# **28F200BV/CV 28F002BV SPECIFICATION UPDATE**

Release Date: February 1997

Order Number: 297612-004

The 28F200BV/CV and 28F002BV may contain design defects or errors known as errata. Characterized errata that may cause the 28F200BV/CV and 28F002BV's behavior to deviate from published specifications are documented in this specification update.

## 6. Write Timing Erratum/Address Timing Erratum

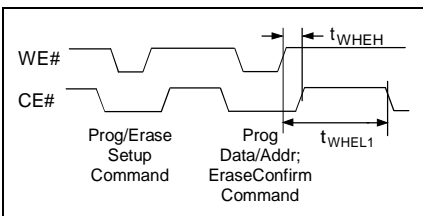
**PROBLEM:** Due to logic timing problems, modifications in write or address timing are required. Two possible workarounds exist: errata A and B. Refer to the following table to determine the operating which applies to your operation conditions. Where the table says, "One of A or B," one of either erratum A **or** B is necessary for proper functionality. Where it says, "A," only erratum A is needed. "Not Affected" means that this erratum does not effect that operation condition.

x8-Mode Operation		x16-Mode Operation	
	$V_{PP} = 5V \pm 10\%$	$V_{PP} = 12V \pm 5\%$	$V_{PP} = 5V \pm 10\%$	$V_{PP} = 12V \pm 5\%$
$V_{CC} = 3.3 \pm 0.3V$	One of A or B	A	Not Affected	A
$V_{CC} = 5V \pm 10\%$	One of A or B	One of A or B	Not Affected	Not Affected

**IMPLICATION:** Applications operating in an affected mode must implement the applicable workaround for proper operation.

**Timing Waveform for WE#-Controlled Writes**

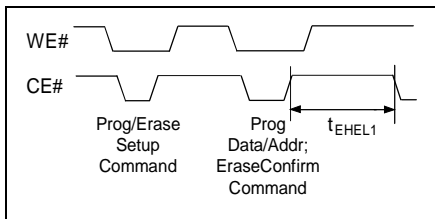
Due to a logic timing problem, new timing restrictions may be necessary between the WE# and CE# signals during write operations. The timing waveforms and specifications are shown below:

Symbol	Parameter	Datasheet		Errata		Units
		Min	Max	Min	Max	
$t_{WHEH}$	CE# Hold Time from WE# High	0	no spec	0	5	ns
$t_{WHEL1}$	CE# Pulse Width High from WE# High	no spec	no spec	110		ns

Erratum timing for  $t_{WHEL1}$ , given above, is required only after the second WE# pulse in a WE# controlled write sequence.

1. Take CE# to logic high no earlier than WE# goes high and no later than 5 ns after WE# goes high.
2. Hold CE# high for at least 110 ns, starting from the time WE# goes high.

These timing specifications must be met for proper operation of the device. The flash memory chip select must go inactive within 5 ns of a program/erase operation and remain inactive for a period of 110 ns before going active again. Consider the following options for meeting the  $t_{WHEL1}$  or  $t_{EHEL1}$  requirement :

1. Follow a program/erase two-write sequence with an access to another memory so as not to decode the flash memory chip select for the required period of time.
2. Insert one or more no-op commands following a program/erase two-write sequence, again to ensure the flash memory chip select is disabled for the required period of time.

Depending on your system implementation, the  $t_{WHEH}$  requirement may require additional logic to ensure the required  $t_{WHEH}$  timing. Evaluate your system timing to ensure the new write requirements can be met. This erratum has been fixed in B-step material.
